TECHNICAL INFORMATION

74499

October, 2005

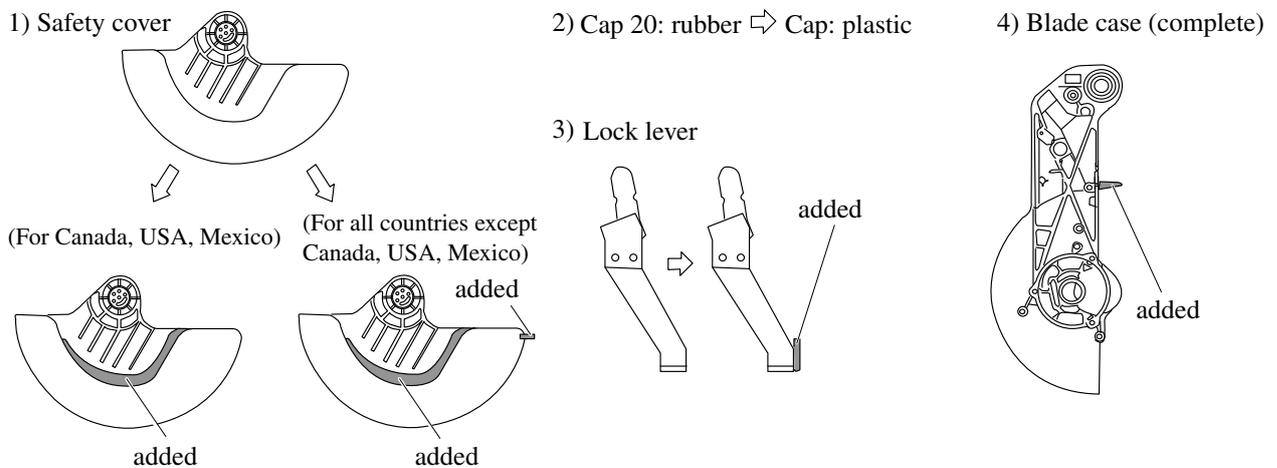
- Subject** ▶ Change of Safety Cover, Cap 20, Lock Lever and Blade Case Complete
- For Models** ▶ See below.
- Country** ▶ All countries
- Description** ▶ For complying with the European standards;
- 1) Safety cover has been modified. The new type Safety cover for Canada, USA and Mexico differs from the new one for the other countries.
 - 2) Cap 20 of rubber has been replaced by Cap of plastic. This modification applies to the model BLS820 for all countries except Canada, USA and Mexico.
 - 3) Lock lever of the models BLS820 and LS800D has been modified for Austria, France, Germany, Italy, Netherlands, Russia, Spain, Sweden, Switzerland, Algeria, Reunion, South Africa and China.
 - 4) At the same time on the modification of 3), Blade case or Blade case complete has also been modified for several countries.
- See illustration below for the added portions.

Item No.	Current part		Q'ty	I/C	New part		Q'ty	Note
199	Safety Cover 416908-2		1	Yes	Safety Cover 419481-1		1	LS0813, LS0813F, LS0811 and LS800D for all countries.
064	Safety Cover 416908-2		1	←	Safety Cover 419435-8		1	BLS820 for Canada, USA and Mexico
113	Cap 20 286212-1		5	←	Cap 416972-3		5	BLS820 except Canada, USA and Mexico
E05	Lock Lever 344807-7		1	←	Lock Lever 345710-5		1	BLS820 and LS800D for Austria, France, Germany, Italy, Netherlands, Russia, Spain, Sweden, Switzerland, UK, Algeria, Reunion, South Africa, China
039	Blade Case 183097-5		1	←	Blade Case 188079-2		1	BLS820 and LS800D for Bhutan, Hong Kong, Australia, New Zealand, Tahiti
039	Blade Case Complete 151904-0		1	←	Blade Case Complete 154940-5		1	BLS820 and LS800D for USA
039	Blade Case Complete 151905-8		1	←	Blade Case Complete 154941-3		1	BLS820 and LS800D for Canada
039	Blade Case Complete 152720-3		1	←	Blade Case Complete 154942-1		1	BLS820 and LS800D for Mexico
